International
Civil Aviation
Organization

Ref.: AN 4/1.1.58-23/33

Subject: Proposal for the amendment of Annex 14,
Volume I and PANS-Aerodromes (Doc 9981)
relating to aerodrome design and operations

Proposed amendments to obstacle limitation surfaces

Figure 4-1. Approach surface and transitional surfaces

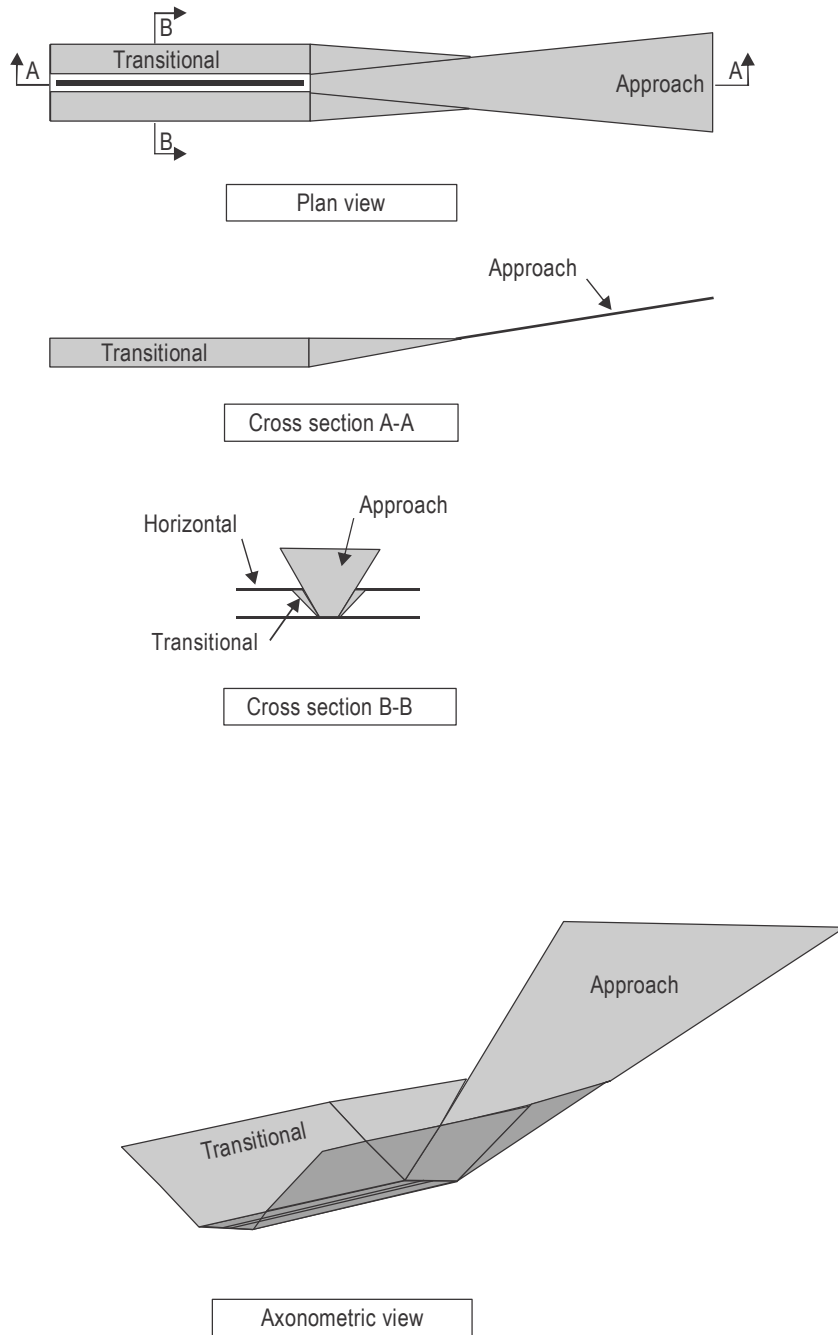
Note.— The purpose of the transitional surfaces is to establish the volume of airspace to be maintained free from fixed obstacles to protect an aeroplane in the overflight of the runway or go-around manoeuvre following a standard 3.0° approach, beyond the approach surface. See Figure 4-1.

| <p>Origin: OLSTF/24 ADOP/4</p> | <p><i>Rationale</i></p> <p>The note gives the specific operational objective of the transitional surfaces. It is to protect the aeroplanes during the overflight of the runway (i.e. after crossing the inner edge of the approach surface) or go-arounds initiated during an approach following the standard 3.0° slope.</p> <p>Practically, the transitional surfaces cover the volume of airspace that is needed to protect aeroplanes descending to the runway or in the climb phase of a go-around manoeuvre where the approach surface does not provide protection.</p> |

Figure 4-2. Inner approach and inner transitional surfaces on a non-precision approach runway

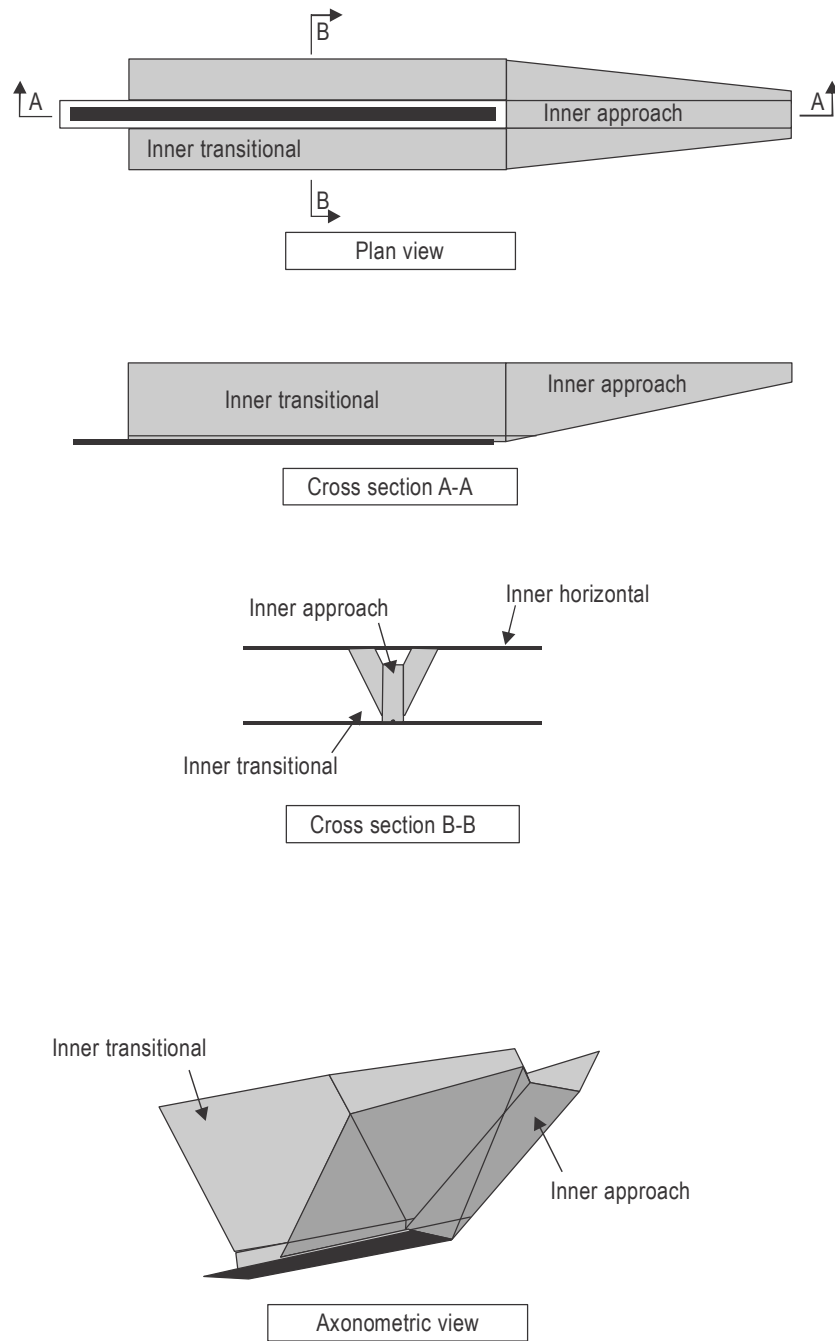
Note.— The inner approach surface protects an aeroplane against fixed and mobile obstacles before the threshold, in the descent phase of the balked landing or late go-around manoeuvres following a standard 3.0° approach. See Figure 4-2 and Figure 4-3.

| <p>Origin: OLSTF/24 ADOP/4</p> | <p><i>Rationale</i></p> <p>The above note gives the specific operational objective of the inner approach surface: the protection of aeroplanes during late go-arounds and balked landing manoeuvres initiated during a straight-in approach following the standard 3.0° slope. The inner approach surface preserves the descent phase before the threshold while the remaining part of the descent phase and the climb phase are protected by the inner transitional surface.</p> |

Figure 4-3. Obstacle free zone on a precision approach runway

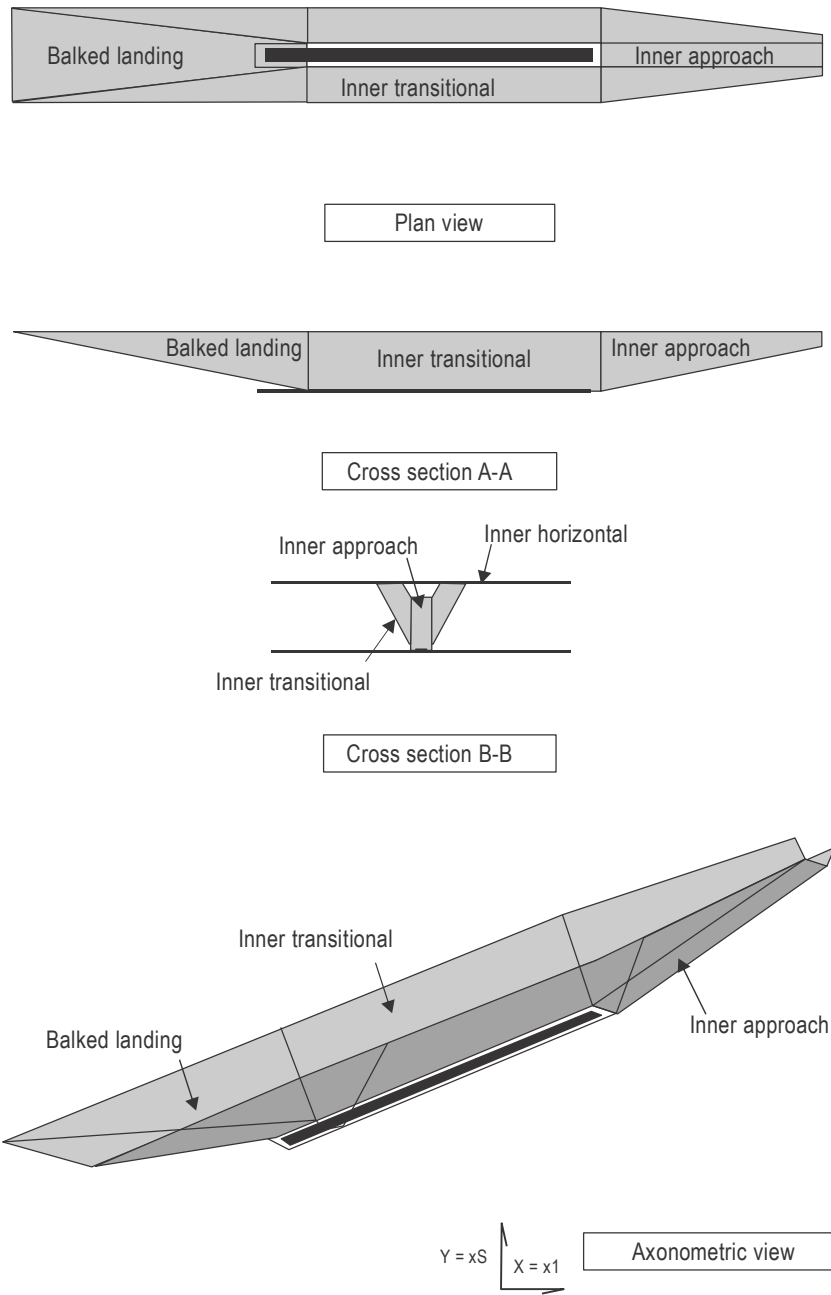
Note.— The balked landing surface is intended to be implemented on precision approach runways, where the balked landing might be initiated at low height above the threshold and the climb phase of the manoeuvre is not necessarily covered by the inner transitional surfaces. The balked landing surface aims at establishing the airspace to be maintained free from fixed and mobile obstacles to protect an aeroplane in the climb phase of the balked landing or late go-around manoeuvres following a standard 3.0° approach, beyond the inner transitional surfaces. See Figure 4-3.

Figure A2-1. Isocandela diagram for approach centre line light and crossbars (white light)

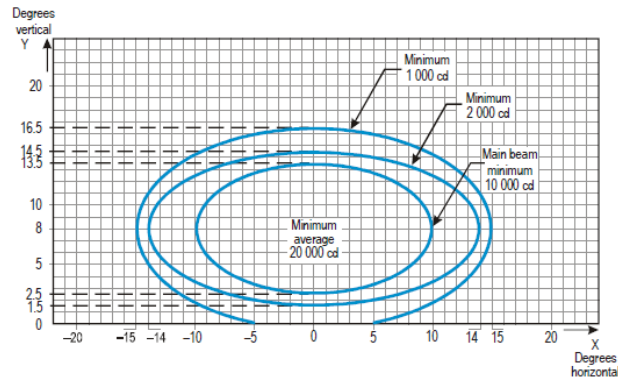
Note 4 of the collective notes to Figures A2-1 to A2-11, A2-26 and A2-27 establishes values for aeronautical ground lights as a ratio of the minimum average intensity of a runway edge light, and is amended to correspond with the changes to 10.5.1 and 19.2.18 Site standard.

The ratio given by Note 4 with Figure A2-1 does not correspond with the value in Figure A2-1. The figure requires a minimum average intensity of 20.000 cd, Note 4 requires a minimum average intensity of 1.5 times the minimum average intensity of a new Runway edge light (10.000 cd) which is only 15.000 cd. The note was amended to require a minimum of 2.0 times the minimum average intensity of a new runway edge light (10.000 cd) which is 20.000 and corresponds with the value in Figure A2-1.

The acceptable maximum value of 2.0 given by Note 4 with Figure A2-1 should consequentially be amended since 2.0 is the minimum value according to Figure A2-1. Maintaining the current intensity difference of 1 to 2.66 (50 per cent of 1.5 to 2.0) would lead to a new ratio of 2.0 to 2.67. This maximum value of 2.67 is rounded to a value of 3.0. This will limit the intensity difference to 1 to 3 (50 per cent of 2.0 to 3.0). An acceptable value, since it is used for the threshold and using 3.0 and not 2.67 increases the ease of use of the ratios.

Figure A-10. Runway distance remaining sign configurations

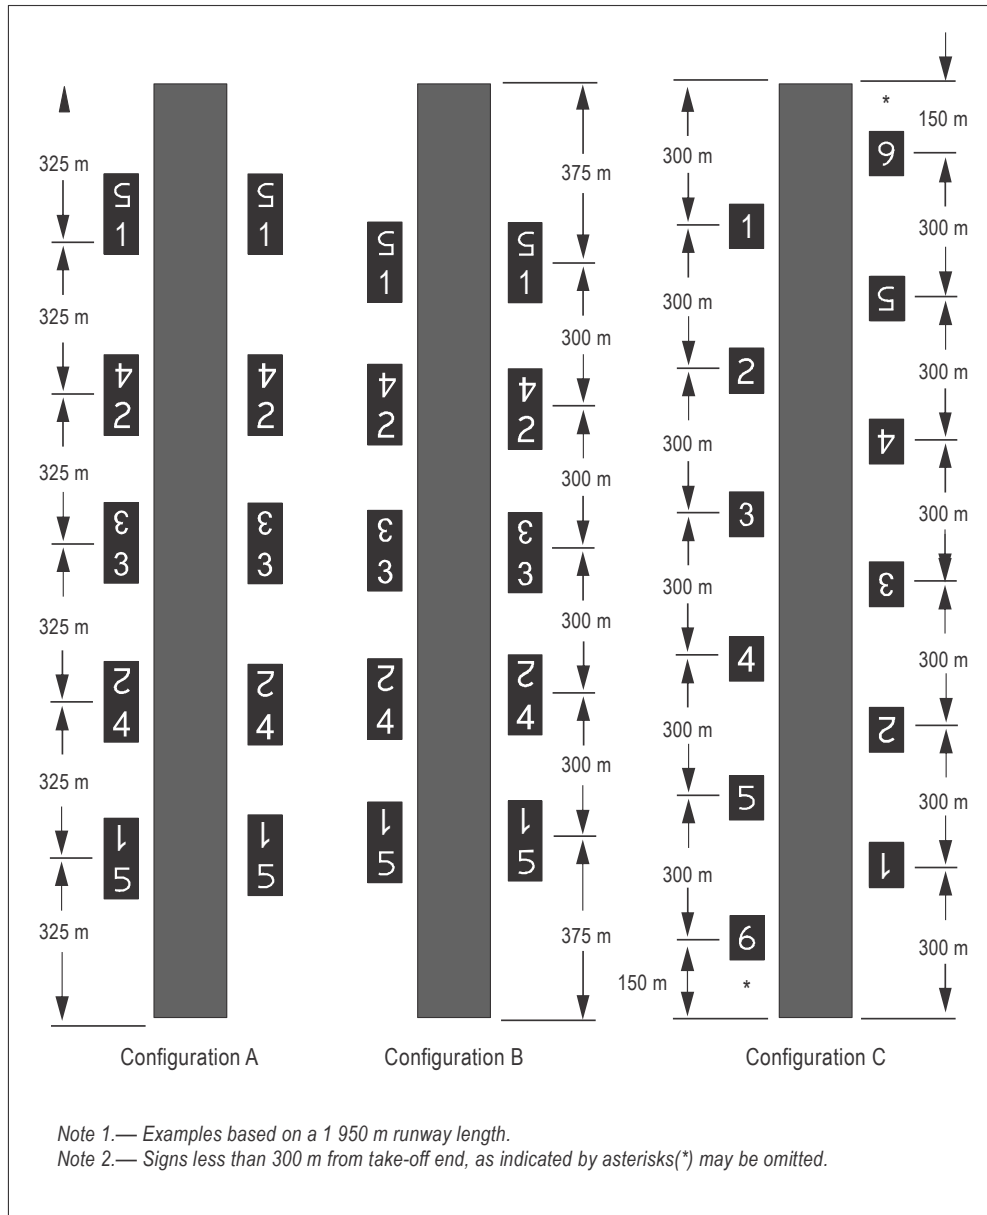
23.2 RDRSs are placed along the full length of the runway at longitudinal spacing of 300 m (± 30 m), parallel and equidistant from the runway centre line as in Configurations A, B or C, illustrated in Figure A-10. RDRSs are arranged by any of three different configurations as shown in Figure A-10.

Figure 7-2. Example of equivalent elevated closed runway lighting with five lights per branch

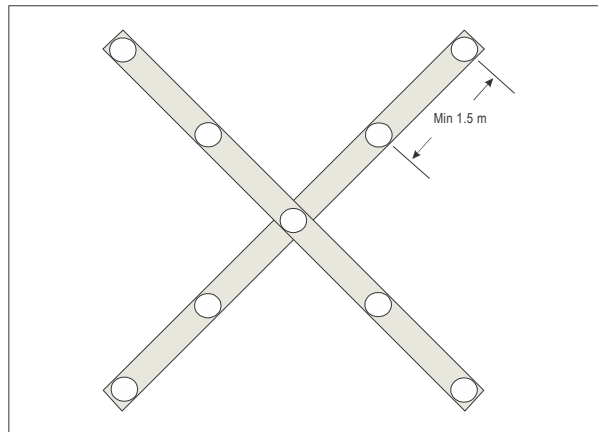
7.1.4.3 The closed runway lighting as viewed by the pilot shall be of the equivalent elevated form and proportions as detailed in Figure 7-2, showing a minimum of five lights uniformly spaced on each branch, with a minimum interval as specified by Table 7-1.

Editorial Note.— Insert new Figure 7-2

Figure 7-3. Examples of unserviceability signs

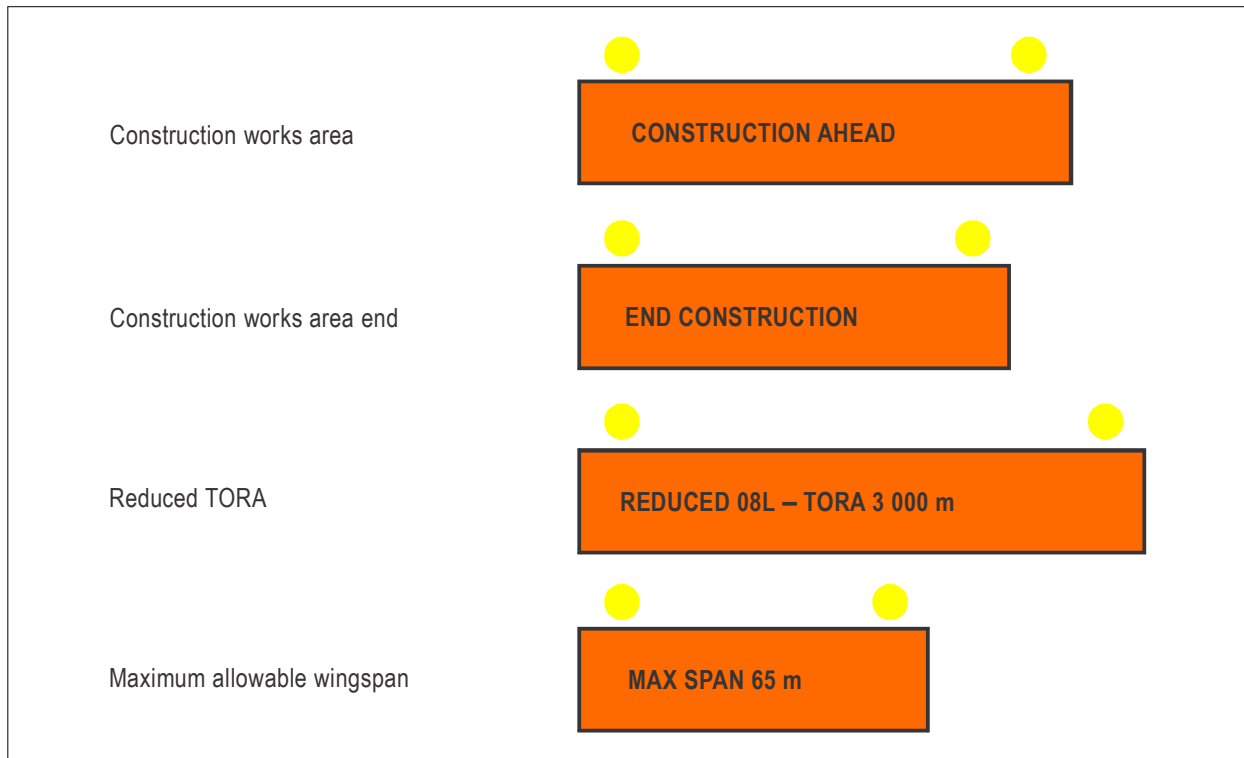
Note.— See Figure 7-3 for examples of unserviceability signs.

| <p>Origin: ADOP/4</p> | <p><i>Rationale</i></p> <p>The need for illuminated vis-à-vis retroflective signs was extensively discussed. Although these signs are runway- and safety-related and thus should be illuminated, other factors such as:</p> <ul style="list-style-type: none"> a) signs being temporary in duration; a) obviate the need for power supply and maintenance; and b) financial costs, <p>had been taken into consideration. On balance, it was felt that these signs needed to be retroflective in order for them to be both simple and cost-effective to install.</p> |

Figure A2-27. Isocandela diagram for closed runway lights (white light)

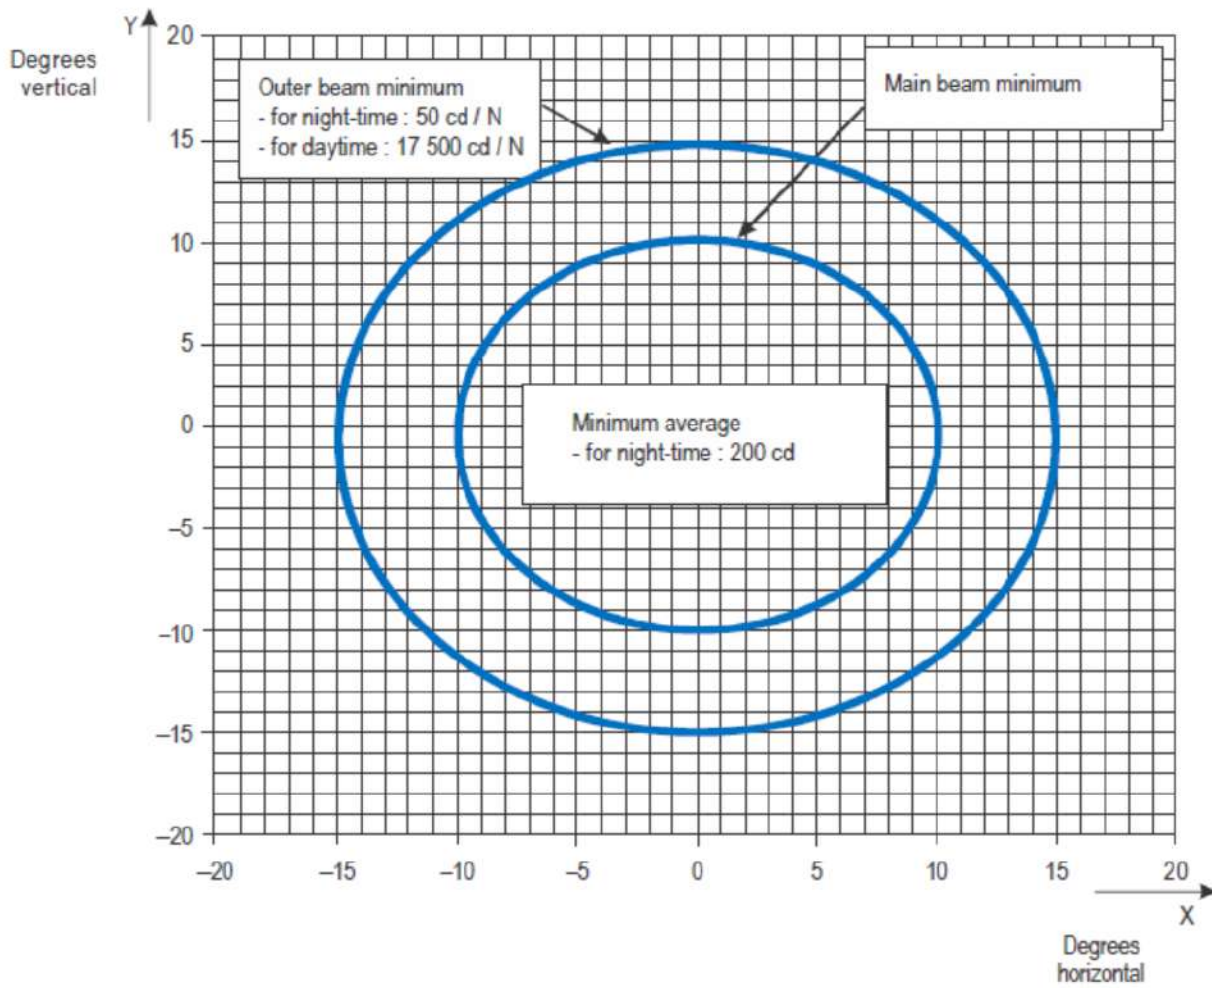
7.1.4.6 Closed runway lights shall be in accordance with the specifications in Appendix 2, Figure A2-27.

Editorial Note.— Insert new figure.

Figure 10-1. Plan view visual segment surface offset final approach with runway centre line crossing

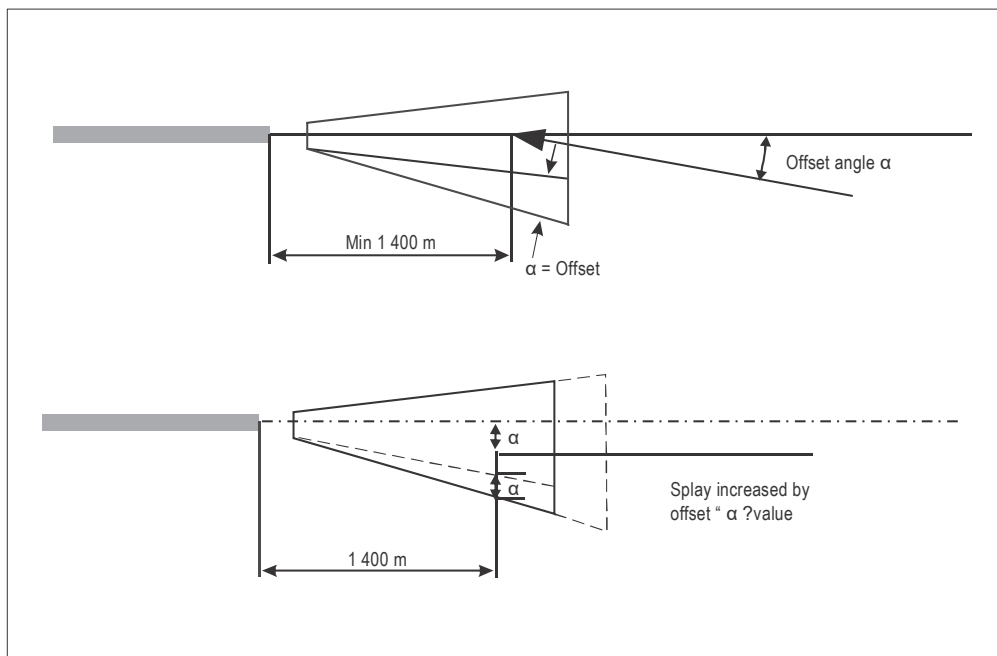
10.3.2.11 Where the final approach track is offset and intersects the extended runway centre line, the splay on the side closest to the final approach track should be increased by the offset angle. Where the final approach track is offset but does not intersect the extended runway centre line, the splay closest to the final approach track should be increased by an amount equal to the final approach course offset at 1 400 m from the runway threshold.

Figure 10-2. Modifying horizontal OES on a non-circling area

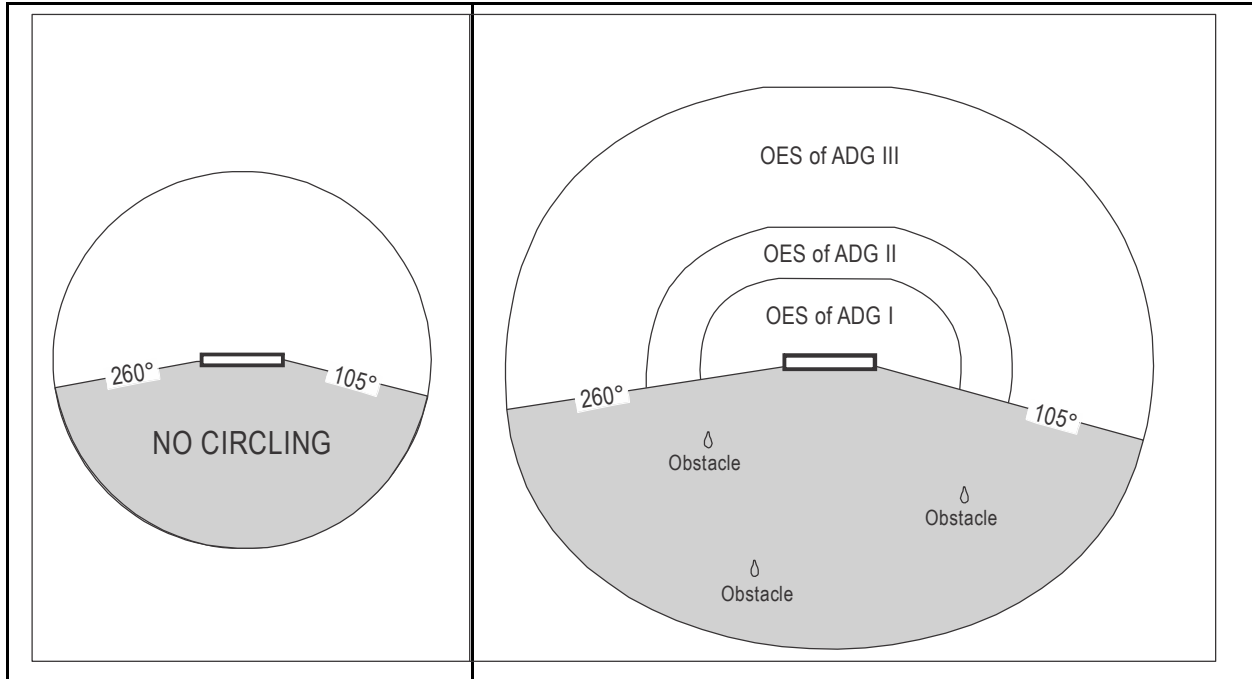
Note 1.— A single or a combination of horizontal OES is to be adopted at aerodromes where there are circling operations.

Note.2.— It must be ensured that the modification of the horizontal OES will not impact the safety of visual procedures and aerodrome circuits, nor significantly affect the regularity of other flight procedures including instrument approach and departures procedures.
